Title: Advisory Committee on Reactor Safeguards
 Reliability and Risk Assessment
Subcommittee

Date: Friday, March 27, 2009

The purpose of this meeting is to discuss example uses of the guidance and performance of sensitivity and uncertainty analysis as described draft NUREG-1855, guidance on the treatment of uncertainties associated with PRAs and risk informed decision making. And the latest version of the companion EPRI report, treatment of parameter and modern uncertainty for probable risk of risk assessments, dated April 2008.

- Discuss staff resolution of ACRS comments on Appendix A to NUREG-1855
 - Overview of major comments
 - Walk-through of the revised document
- Future work

Figure A-1 Simplified Seismic Initiator Event Tree

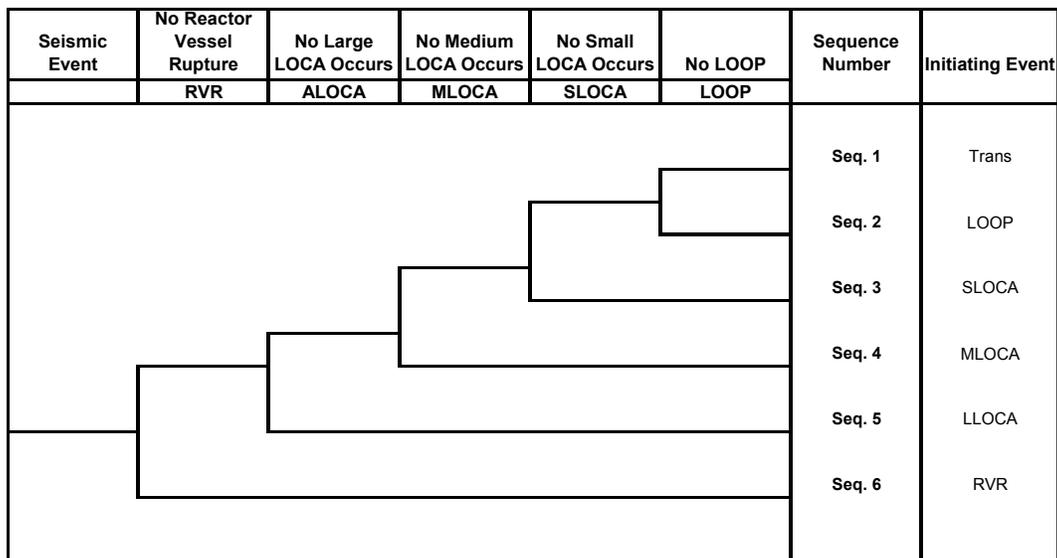
17 MR. VANOVER: Right. So then when we get
18 in to the details of the discussion of the bounding
19 seismic assessment, we added some clarification to the
20 LOOP section on the top of page A-14.

5 CHAIR APOSTOLAKIS: Just a minor comment.
6 On the second yellow. From Table A-9 it can be seen
7 that the frequency of seismic can induce small,
8 medium, or large LOCA. Not "and". "Or". And that
9 was any one of them.

³ The ability to assess seismic contributors to an application is specific to the plant and change being evaluated. This example is not to be construed as providing generic dispositions of the seismic risks.

In the internal events PRA, LOOP events are relatively important contributors to the risk associated with the RHR loop out of service condition. This is due to the loss of condenser condition caused by the loss of offsite power. Given a loss of condenser event, the RHR system and the containment vent are the only two means of containment heat removal available. For the plant being evaluated, the containment vent capability has been seismically evaluated and found to have a significantly higher seismic capacity than the RHR loops. This means that the vent would be expected to be available to mitigate the seismic LOOP condition. Therefore, it can be assumed that seismic-induced LOOP events present a challenge similar to a traditional LOOP, except offsite power recovery is assumed to be precluded, i.e., unrecoverable in the timeframe considered by the PRA.

The risk implications of seismically-induced LOOPS is assessed by comparing the frequency of seismic-induced LOOP events to the frequency of unrecovered LOOP events that are due to other causes (i.e., grid, plant centered, and weather), as treated in the internal events PRA.
